TECHNICAL NOTE – 01: Overland Flow Path adjacent to Chapel	
Project name: Macarthur Memorial Park	Issued to: Dept of Planning & Environment
Project no: 5162001	Prepared by: Niall Quinn Reviewed by: Michael Cahalane
Client: CMCT	Date issued: 18/10/2018
Document No: 5162001-WS+P-CS-TN-0001	Revision: 1

Introduction:

This technical note has been prepared in response to the Department of Planning and Environment query raised by Campbelltown Council in relation to the overland flow path north of the proposed chapel.

TITLE		CHAPEL OVERLAND FLOW PATH	
SCALE	DRAWN	DESIGNED	CHECKED
NTS	M.Cz.	M.Cz.	N.Q.
JOB No.	DRAWING No.	ISSUE	
5162001	SK-41	1	
DATE	STATUS	ISSUE FOR INFORMATION	
18/10/18

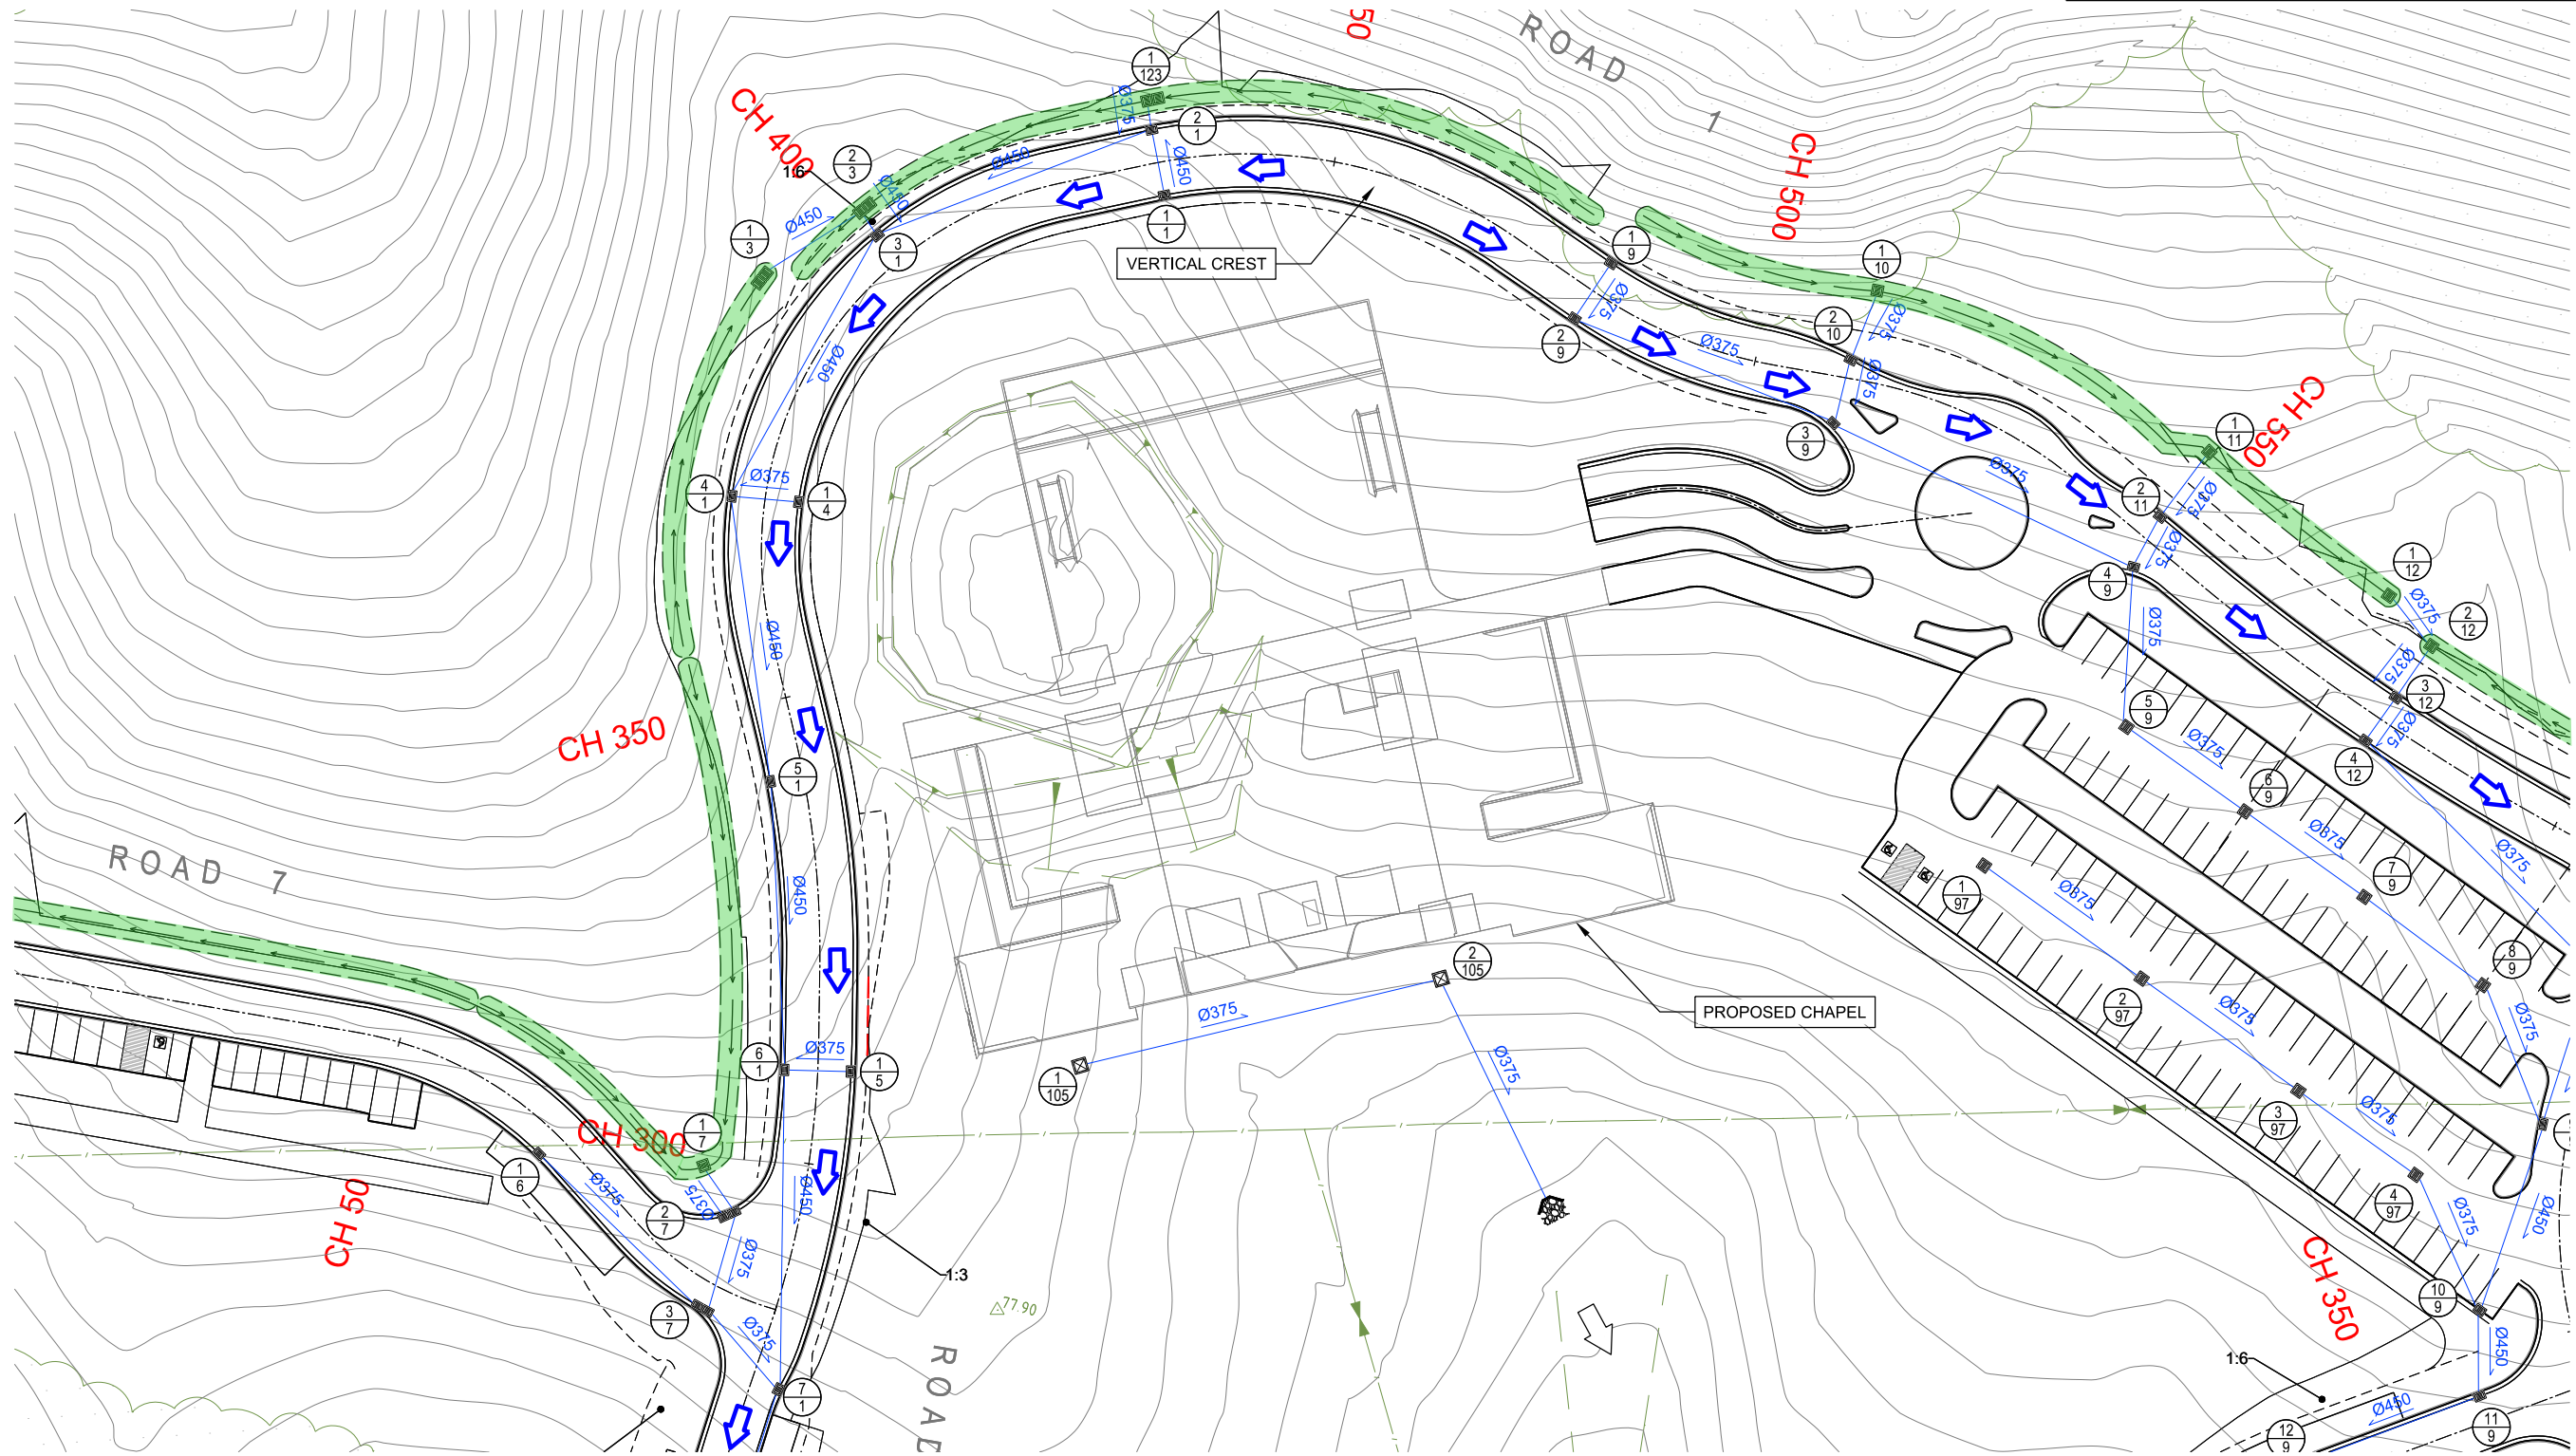
DPE comment: “Campbelltown Council comment regarding the overland flow path of stormwater behind chapel. Despite comment provided by the Stormwater engineer, we have not included a drawing detailing the measures to mitigate the overland flow on Road 1 north (and upstream) of the Chapel.”

The proposed stormwater network consists of a swale (adjacent to Road 1) as well as a pit and pipe system within Road 1 kerb and gutter adjacent to and (north) of the proposed chapel. The swales located north of the road will capture any overland flow sheeting down the hill before reaching the road. This flow will then be conveyed through the pit and pipe system located under the road kerb and gutter.

The stormwater system has been designed based on a minor and major system in line with Campbelltown Council's Development Control Plan. The minor system, designed to a 10-year ARI, will contain all flows within the proposed system therefore resulting in no overland flow near the chapel.

The major system, designed to a 100-year ARI, is designed to safely convey major storm flows when the capacity of the minor system is exceeded. The proposed stormwater system north of the chapel safely conveys overflows within the road network without any potential impact to buildings or public safety in the 100-year ARI. Any surcharge from pits near the proposed chapel will be conveyed within the road network away from the chapel. Please refer to attached sketch ‘5162001-WS+P-SK-41 Chapel Overland flow path’ for further details of overland flow paths. Table 1 below also identifies overland flows encountered between each pit near the chapel in the 100yr ARI event. It is evident that the overflows are minor in nature with maximum depths of 89mm.
